**Eugene School District 4J
ROOSEVELT MIDDLE SCHOOL**
680 East 24th Avenue
Eugene, OR 97405
CIP No. 410.566.001

ADDENDUM NO. 3

This Addendum forms a part of the Contract Documents and modifies the original Bidding Documents dated February 18, 2015 as noted below. Acknowledge receipt of this Addendum in the space provided on the Bid Form. Failure to do so may subject the Bidder to disqualification.

WEST LAYOUT PLAN

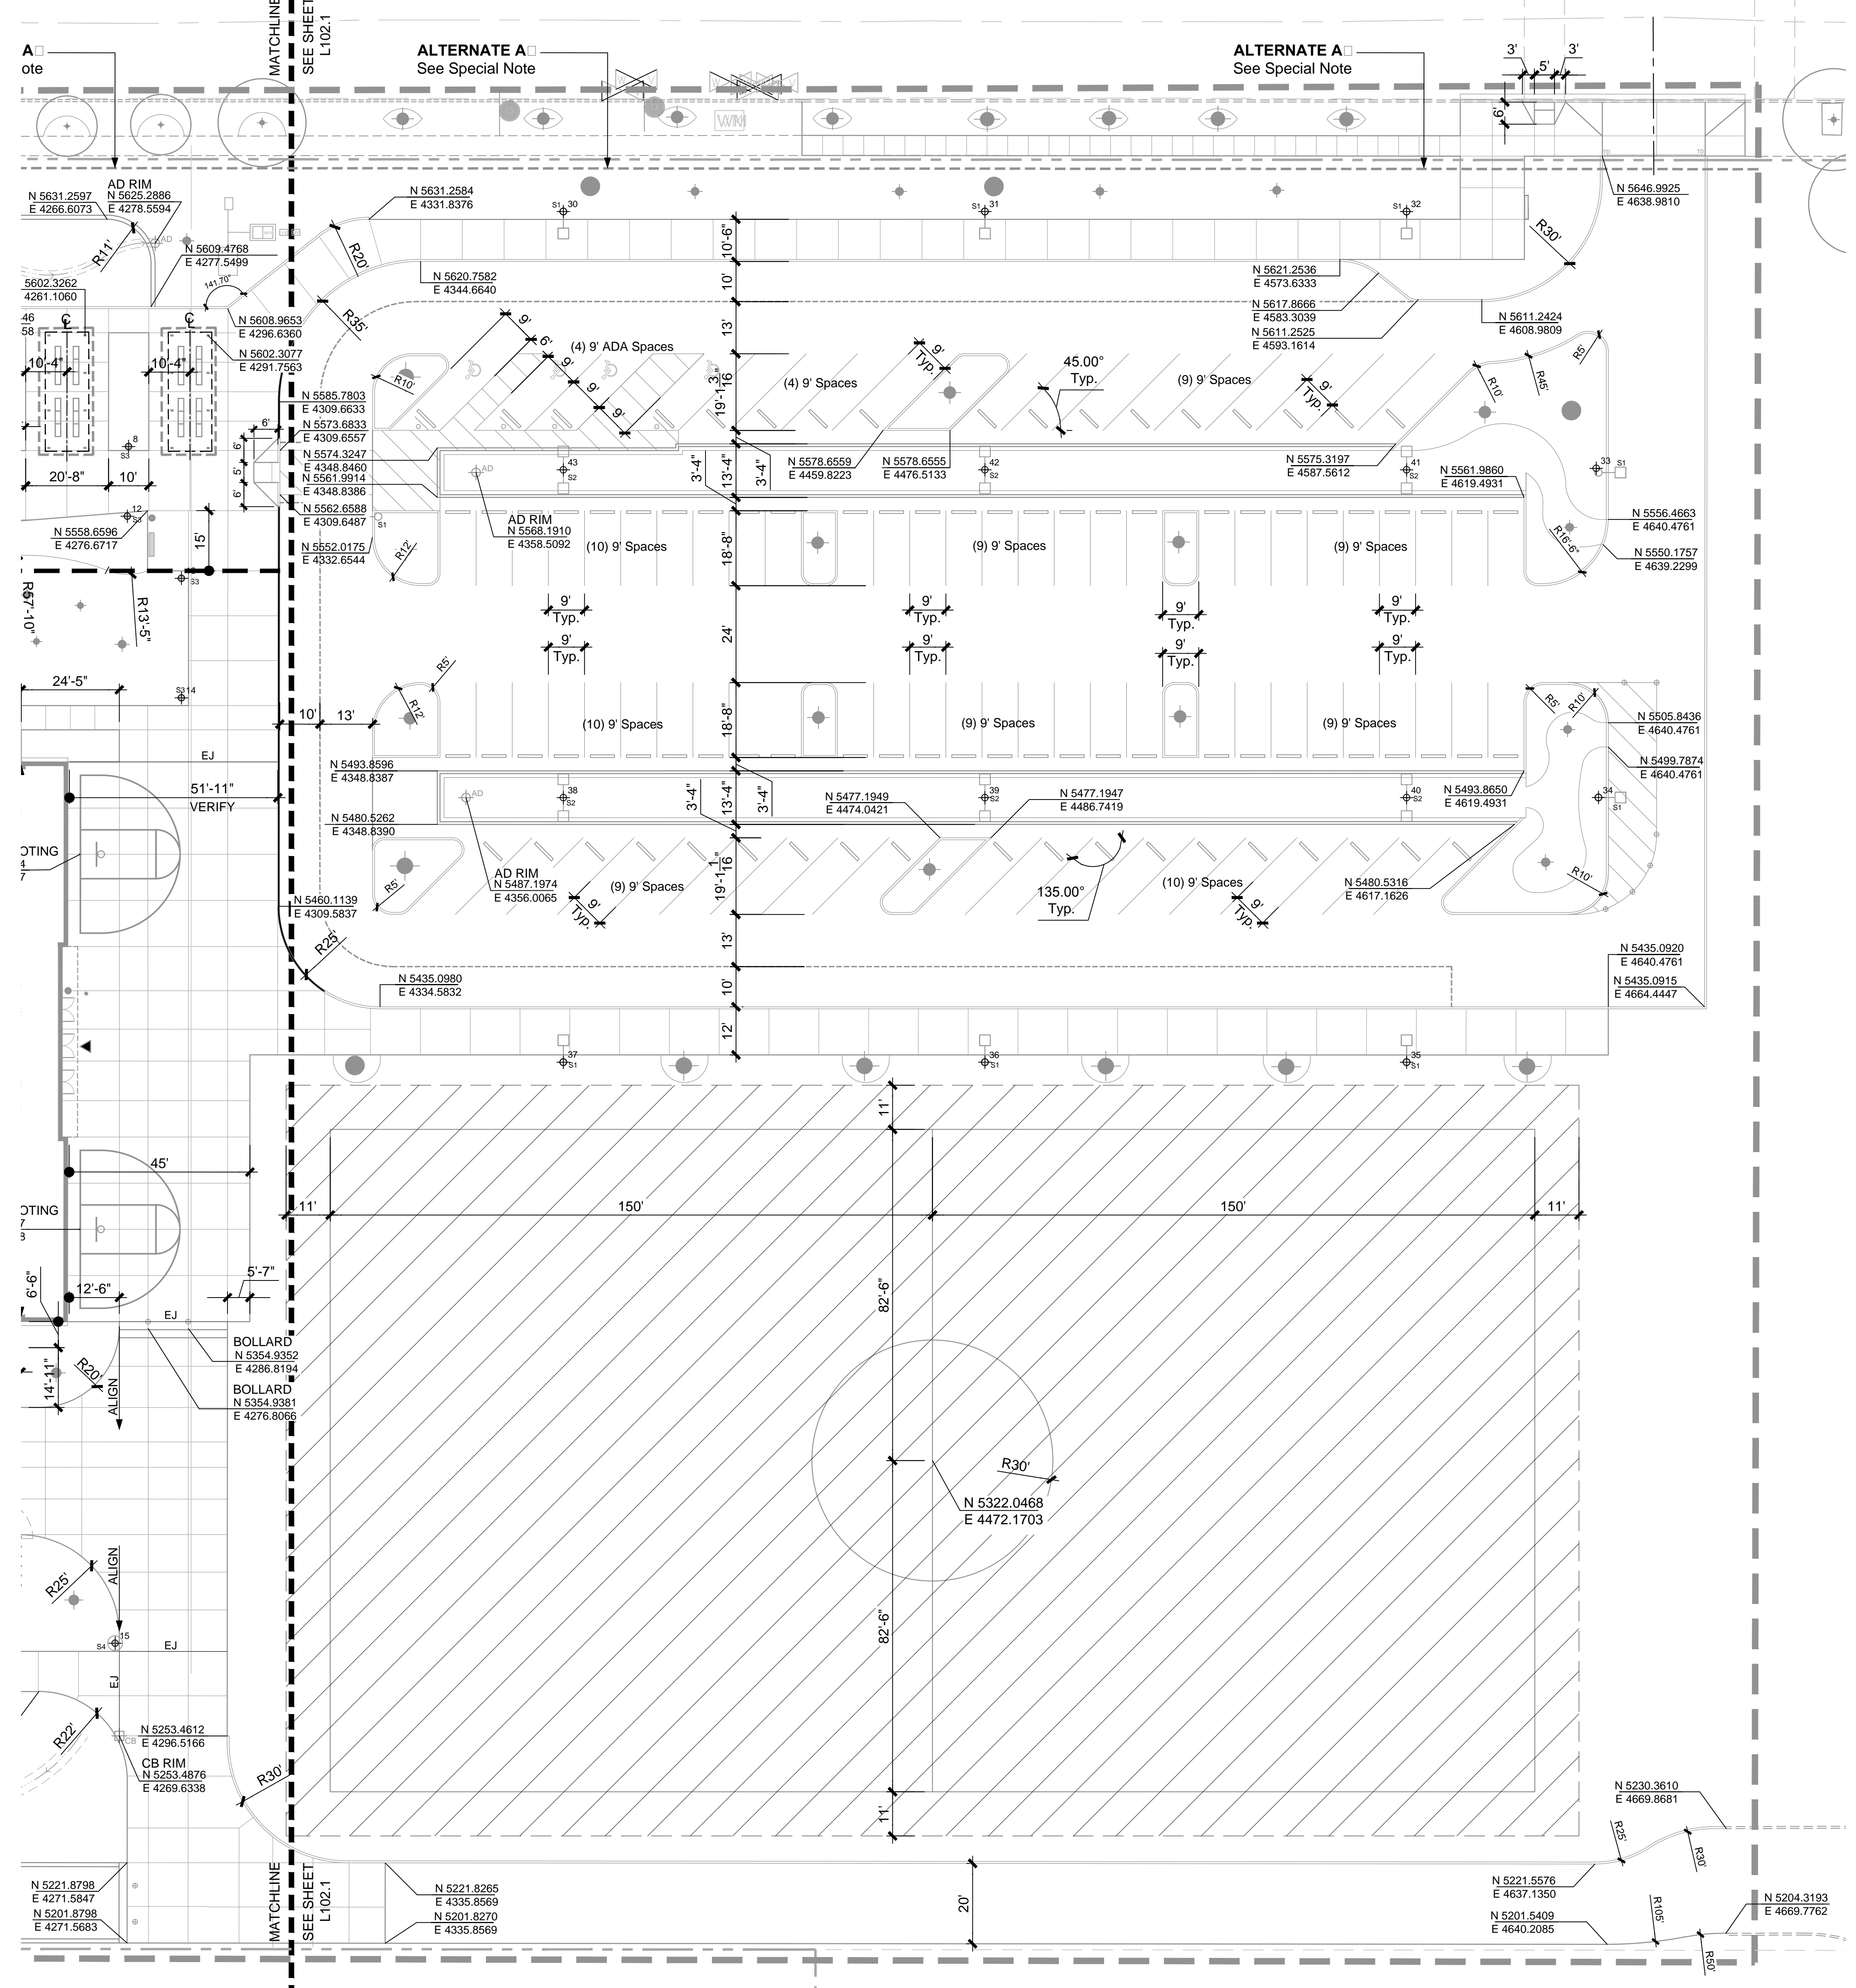
- A. Replace Sheet with attached new Sheet L-102.1. Clarification: Changed northing and easting point of AD Rim at northeast grassy swale. Added northing and easting points at grassy swale concrete header. Adjusted wall light points #44-#50, See Light Schedule. Deleted wall light points #51-#57, See Light Schedule. Updated dimensions at perpendicular sidewalk ramp at the parking lot.

WEST RADIN PLAN

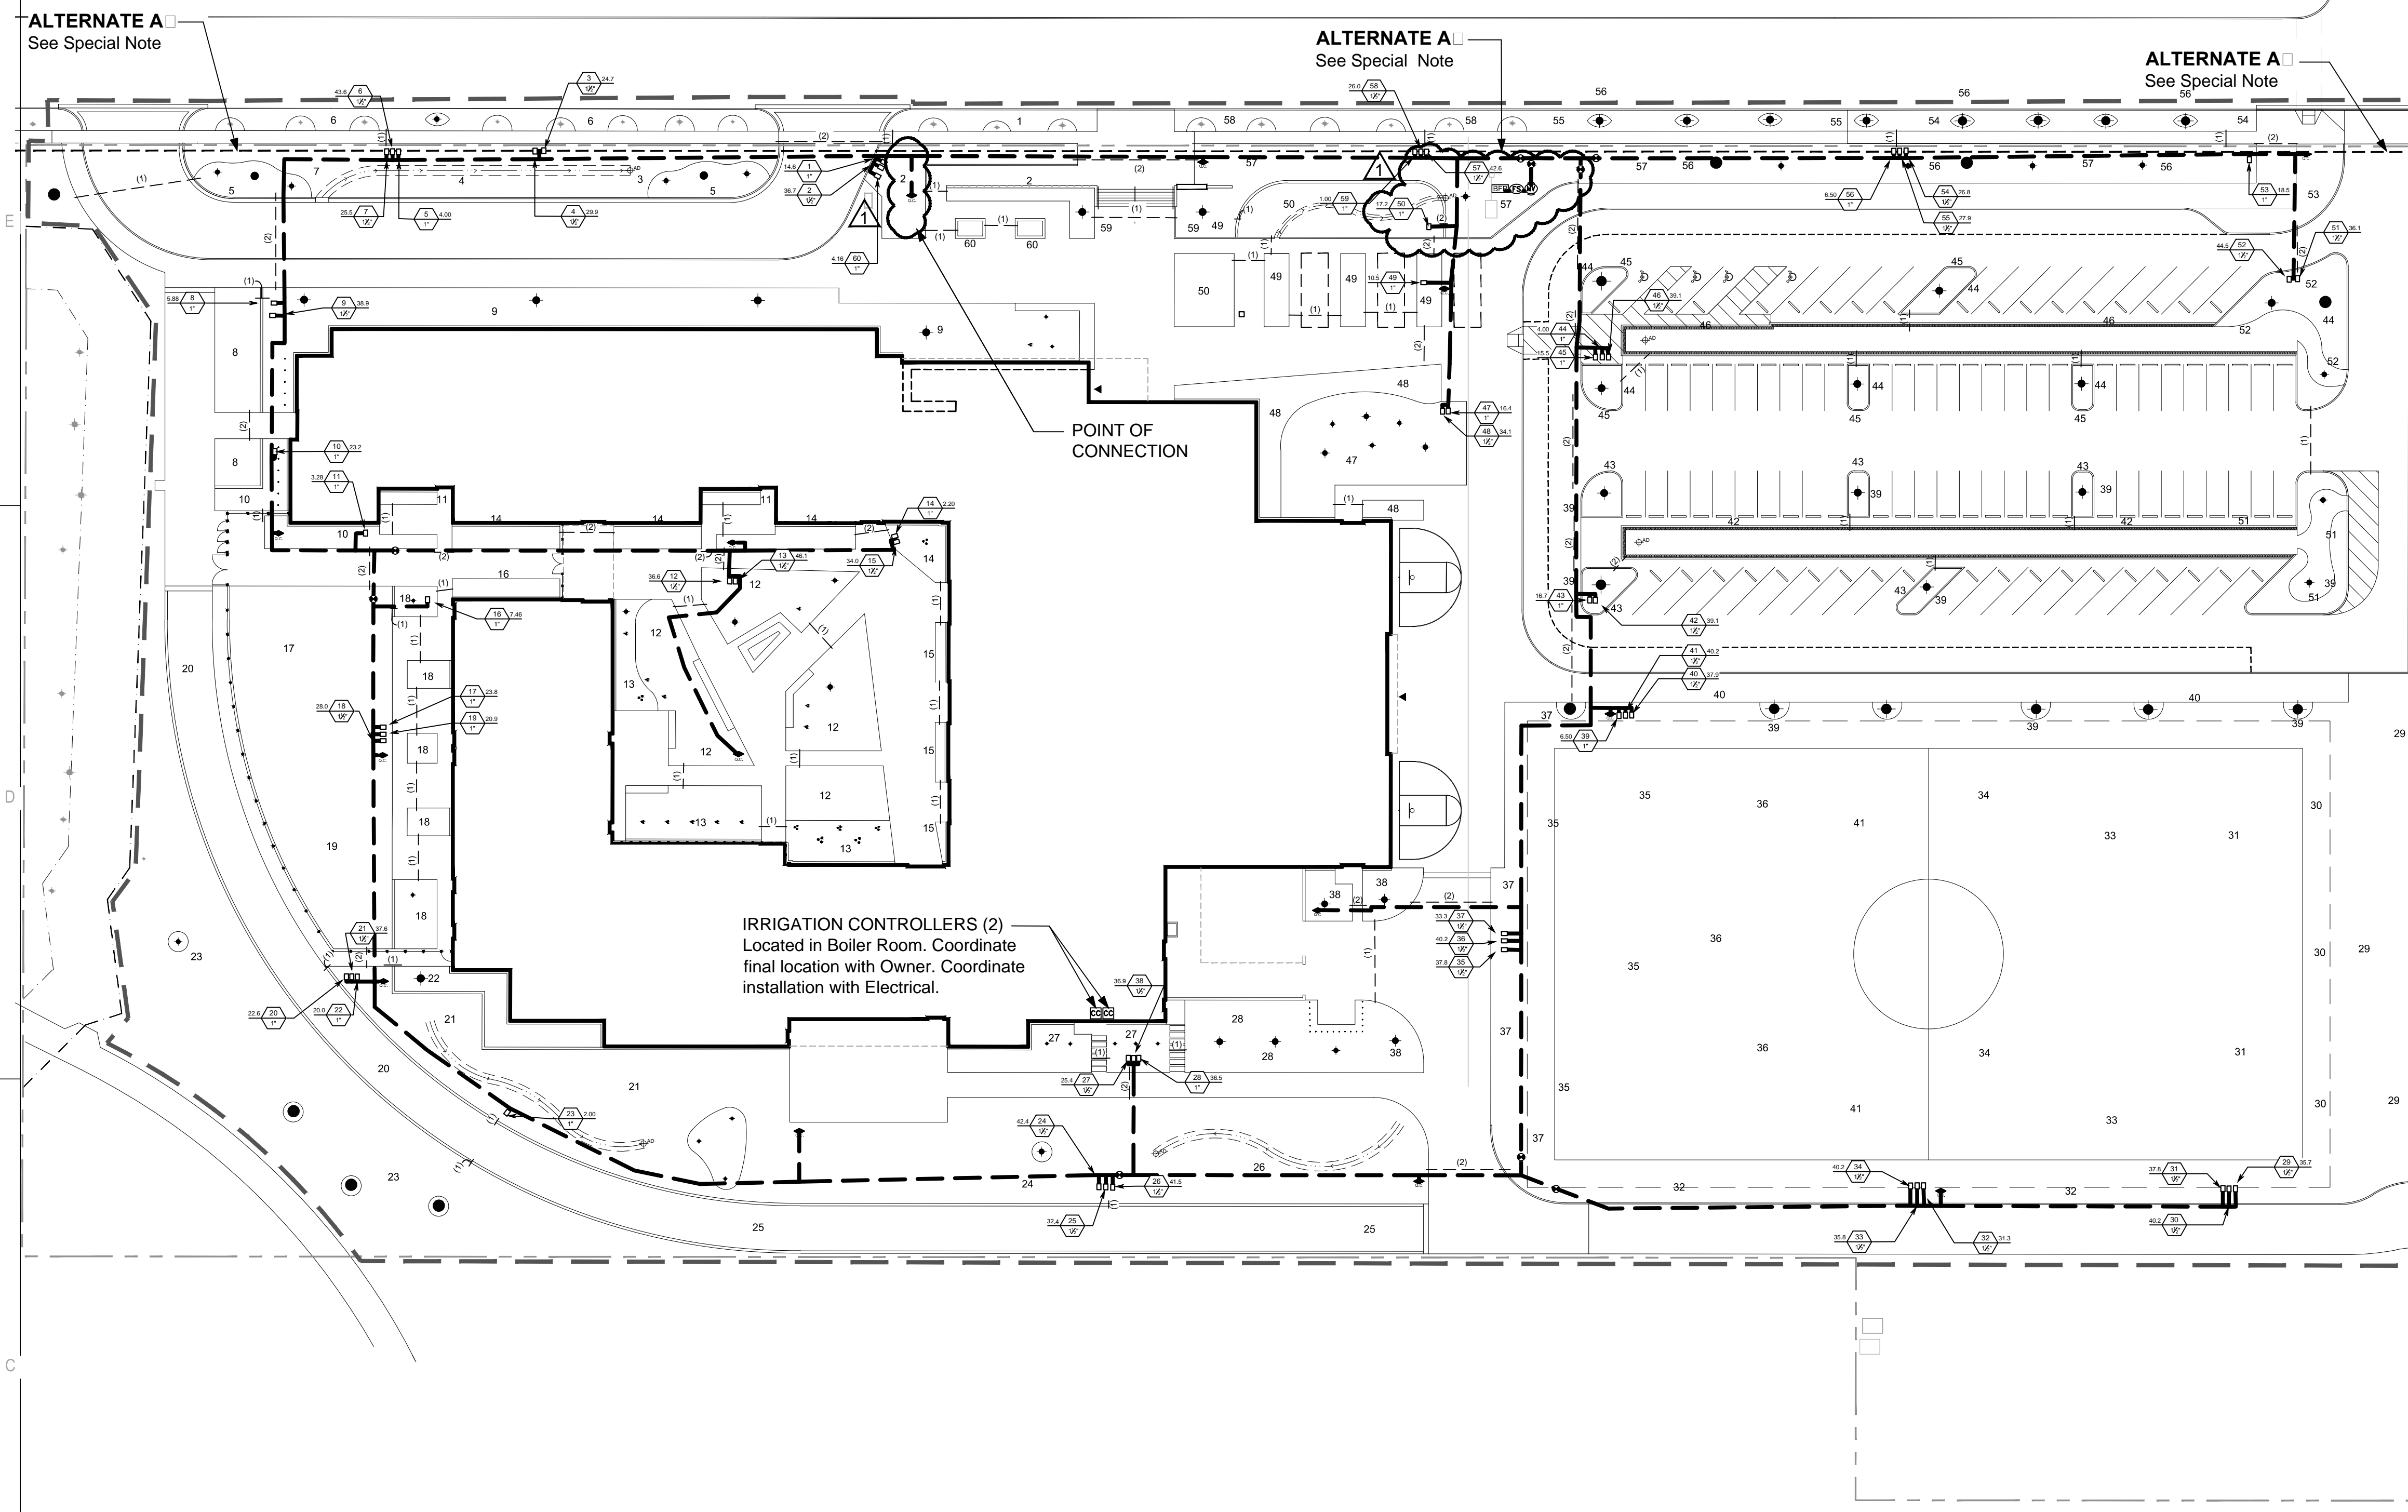
- A. Replace Sheet with attached new Sheet L-103.1. Clarification: Changed elevation of AD Rim at northeast grassy swale. Added elevations at fire suppression vault location.

IRRIGATION NOTES & MAIN LINE PLAN

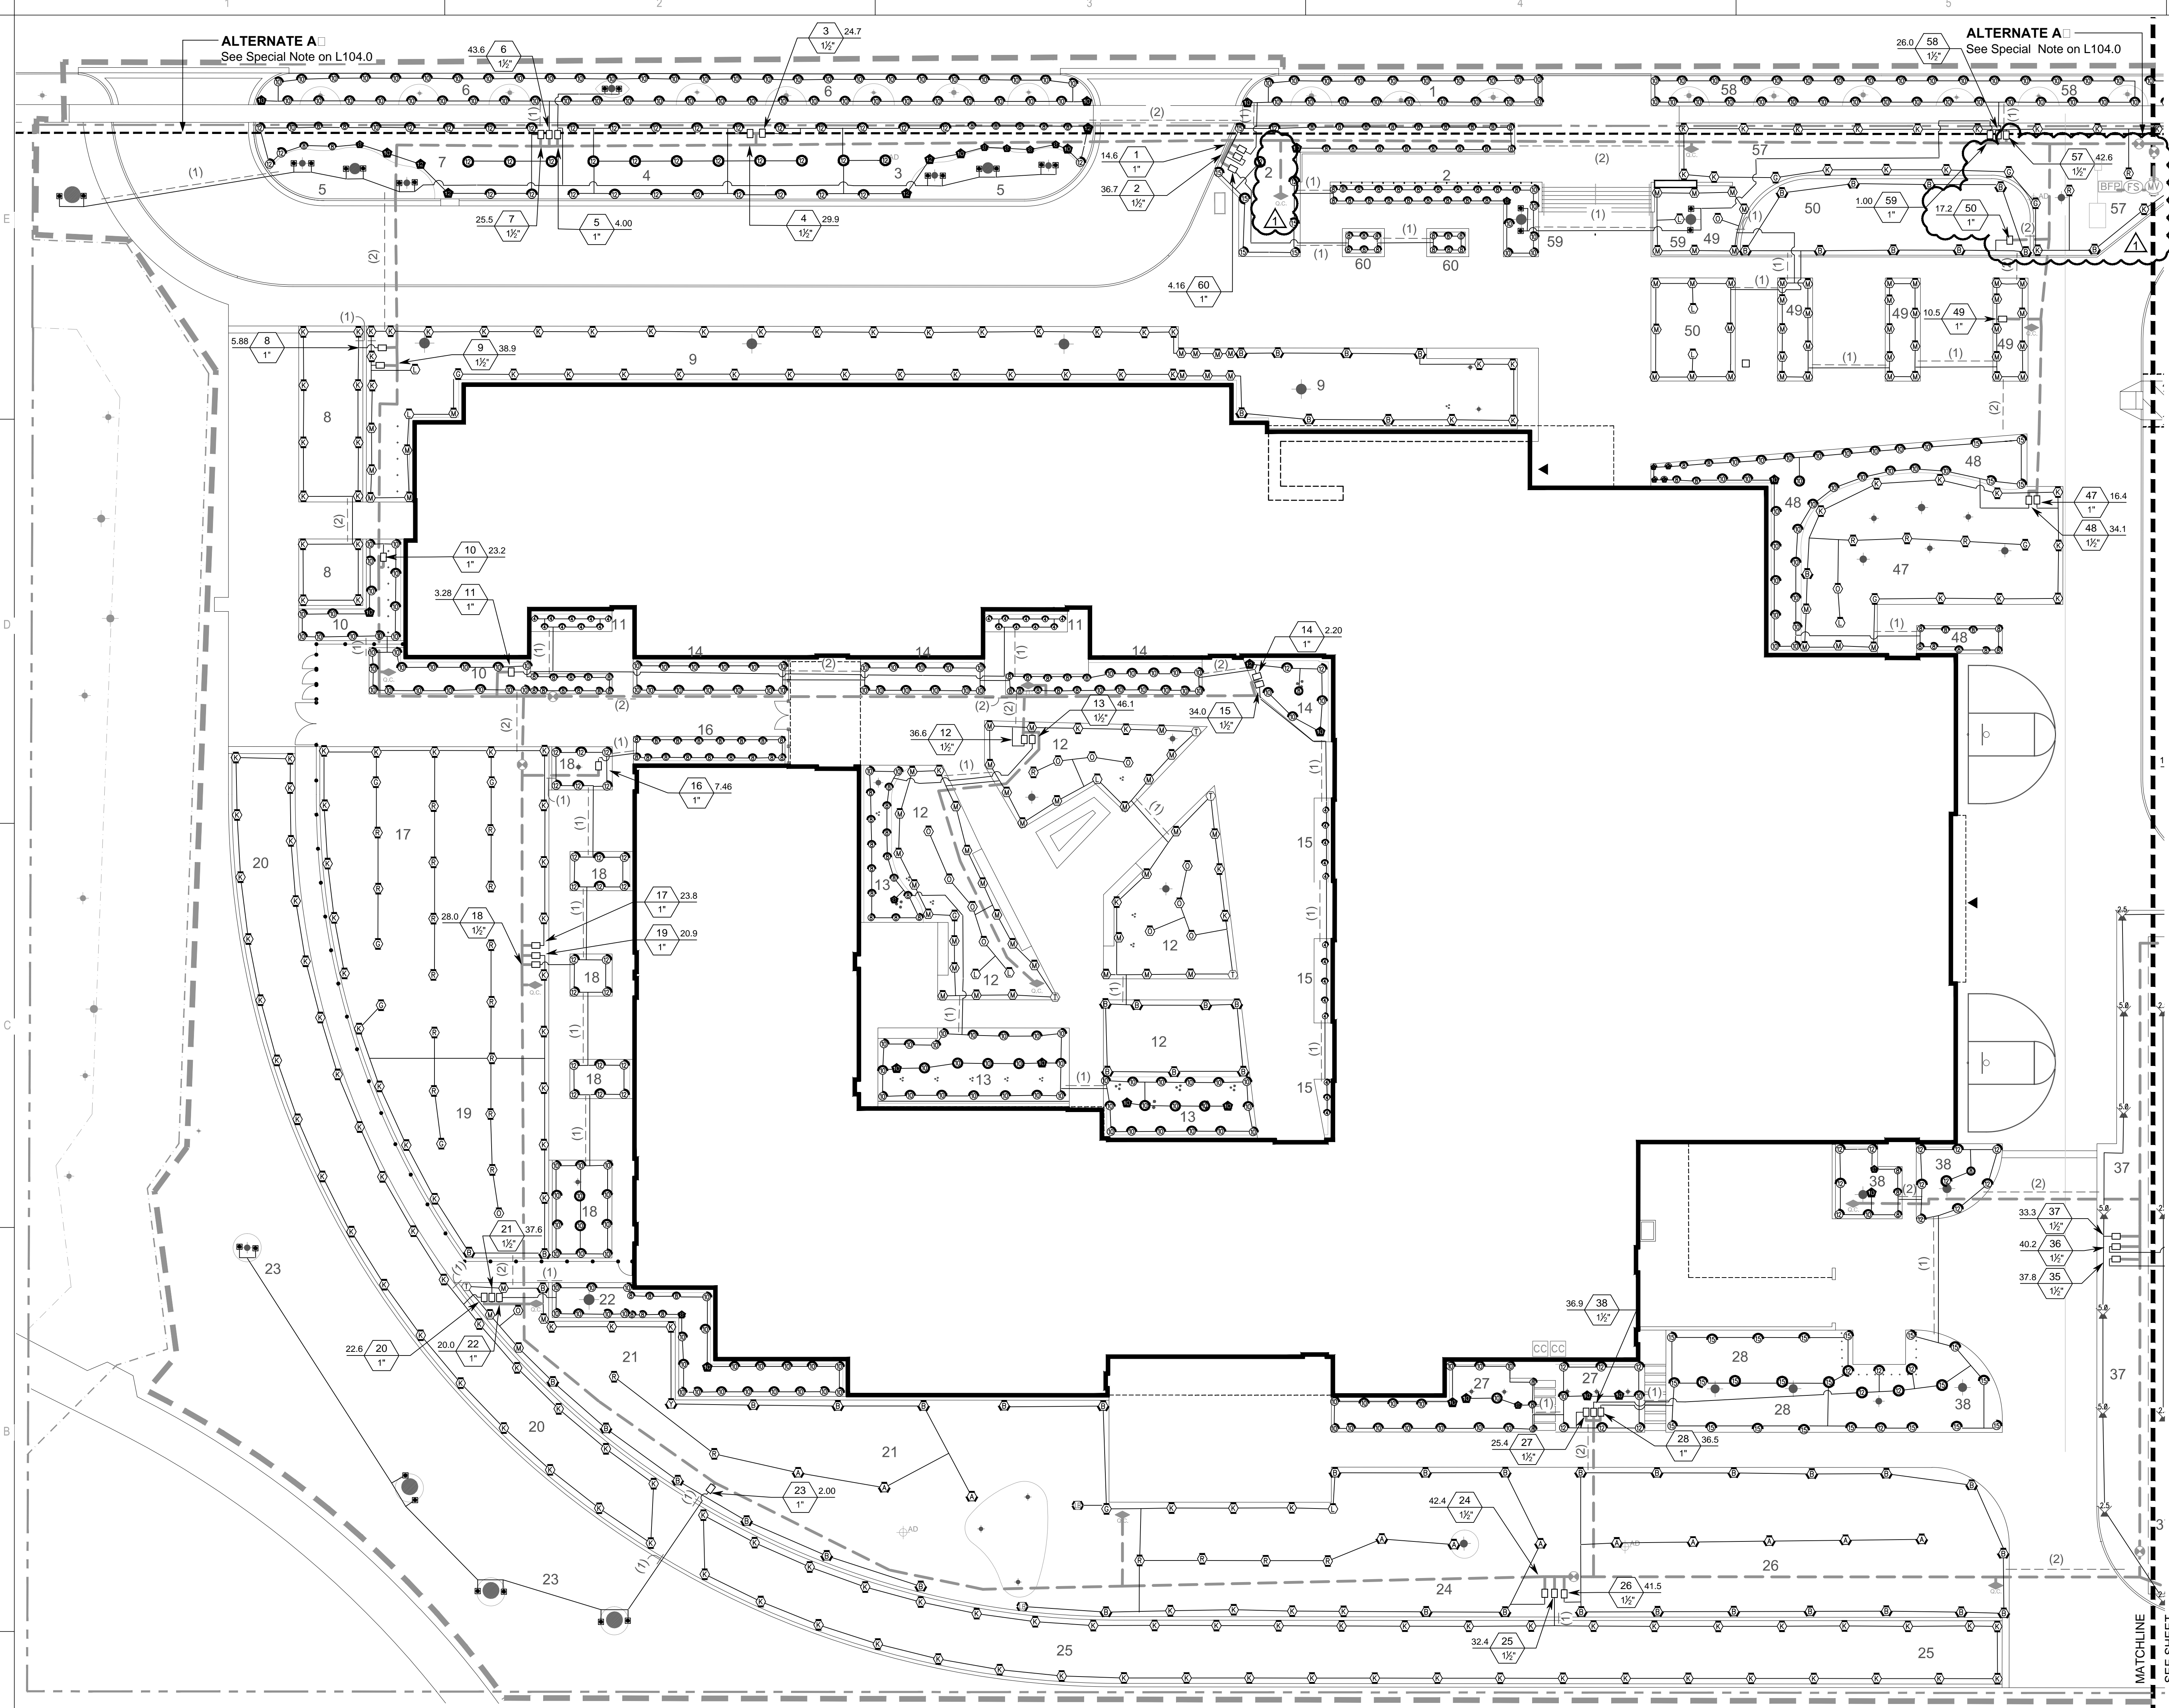
- A. Replace Sheet with attached new Sheet L-104.0. Clarification: Relocated backflow prevention device, master valve and flow sensor per Civil sheets. Changed zone calculations for valves #51 and #57.
